T. TODD MARTIN SUBDIVISION

APPLICATION NUMBER 5 DATE January 18, 2007

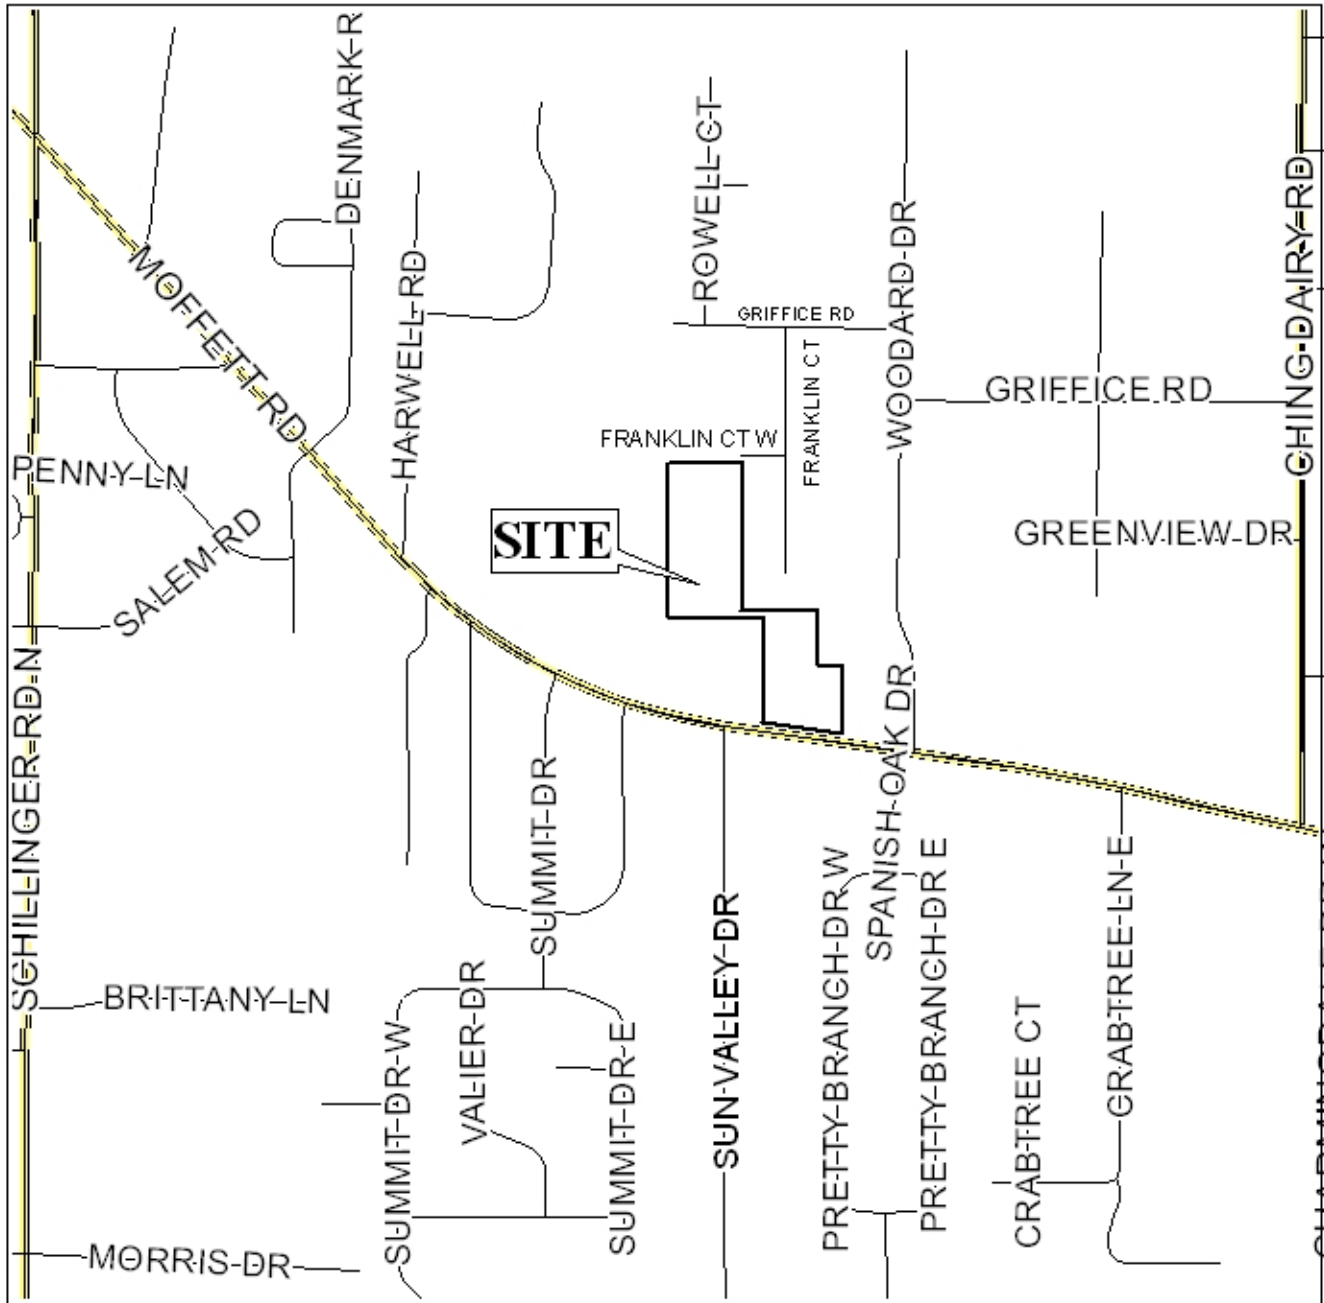
Given the unusual configuration of the existing parcels, it is not possible for Lot 3 to be resubdivided in the future, unless additional frontage on a county maintained road is provided. Therefore, if approved, a note should be required on the final plat stating that there be no future resubdivision of Lot 3 unless additional adequate frontage on a county maintained road is provided. Additionally, there are issues relating to the access for Lot 3 as proposed.

Lot 3 is somewhat of a flag parcel, with approximately 43' of frontage on Moffett Road. However, that access strip then tapers down to approximately 18' where it joins the "body" of the lot. The minimum standard for such access strips on "flag lots" is 25'. The plat shows an ingress / egress easement totaling 24', and running along the lot line between lots 2 and 3,

coinciding with the existing curb cut to Moffett Road. While this easement would provide for access, the lot line between Lots 2 and 3 could easily be reconfigured to maintain a minimum width of 25' for the Lot 3 access strip.
